Land West of Watling Street, Park Street, Hertfordshire

Transport Assessment Addendum 2

18 October 2022

Appendix A. Sketch of Toucan Crossing

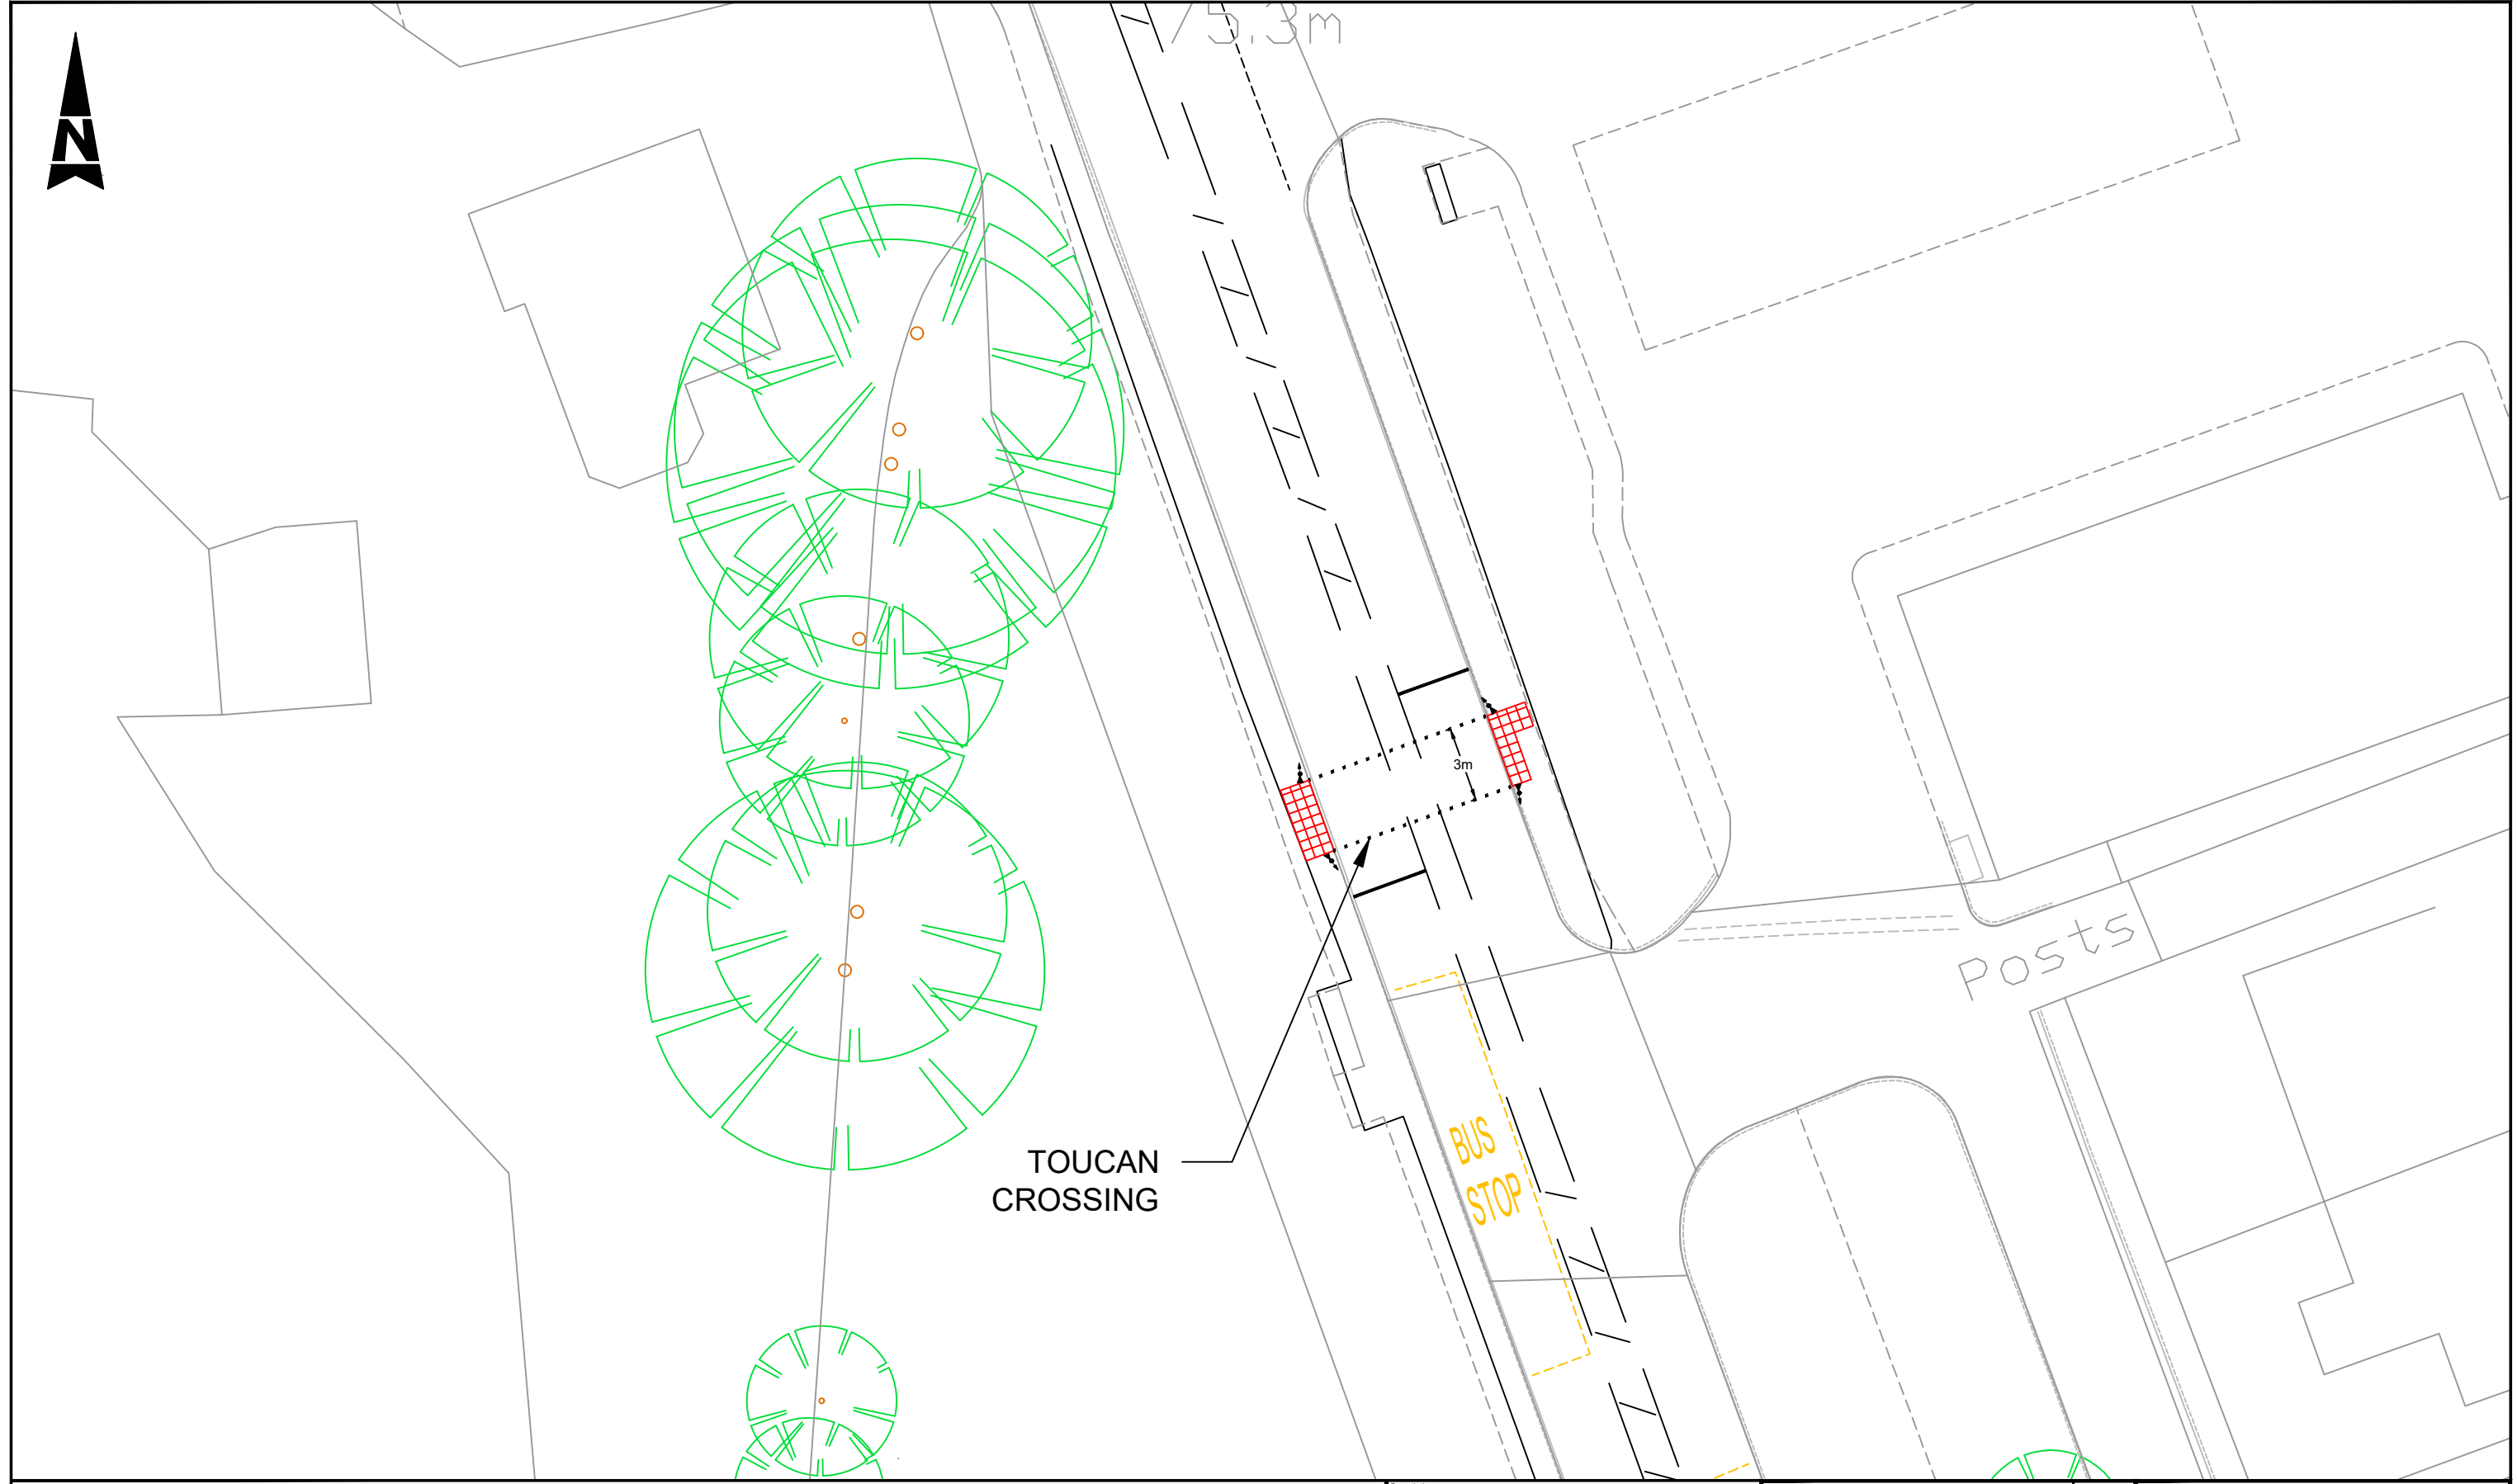
'It was agreed at STIB that the proposed signalised pedestrian crossing to the north of the development must be in the form of a toucan crossing which therefore link in with the existing shared footway /cycle way leading north towards St Albans.'

In order to address the comment from HCC, Atkins has reviewed the design of the crossing located to the north of the development and agreed to facilitate a toucan crossing to allow for both cyclist and pedestrian use. A sketch of the potential crossing is included in Appendix A. This will provide connectivity to other sustainable

travel provisions, such as footways, cycleways, and bus stops along Watling Street and further north towards Park Street Roundabout. The crossing will also be designed with two signal heads to ensure that vehicles can see the crossing is in use even in the event of a bus using the bus stop and potentially restricting the view. By ensuring maximum safety of users and including cyclists as well as pedestrians, this crossing will be compliant with the guidance stated in the LTN1/20 document.
